MMAL DEALER BULLETIN

Bulletin Subject	**Coolant seepage/leakage from core plug at rear of cylinder head on 4N15 Engine.**		
Applicable model(s)	MQ/MR Triton, QE/QF Pajero Sport		
Notice Category	**Hotline fix**	Technical Bulletin	**MQ/MR/QE/QF14-001**
Service Group	14 - Engine Cooling	Latest Revision Issued	22/12/2025
Revision number	C	MMAL Reference	TSL2407029-A

New Assembly Specification - Depth of A, B, C & D are now all within 0.5mm of each other.

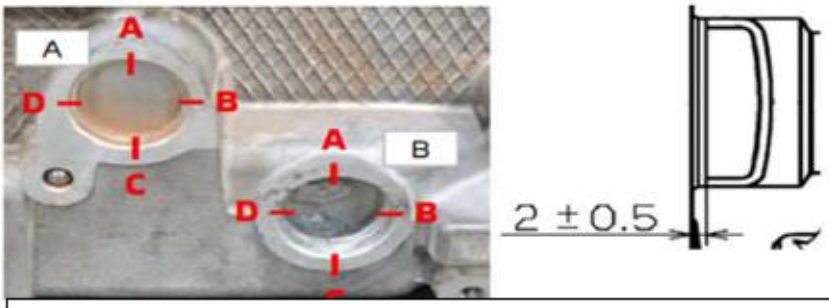
The core plug may have been installed to the incorrect depth or straightness. If this occurs, repeated hot/cold cycling of the engine may allow the core plug to move in the bore. This movement breaks the bond of the core plug adhesive, allowing the core plug to progress to a position that allows coolant to bypass the plug.

2) Reduce the specification for the maximum tilt level of the core plug (Within ±0.5mm at depth points A, B, C & D of the plug).
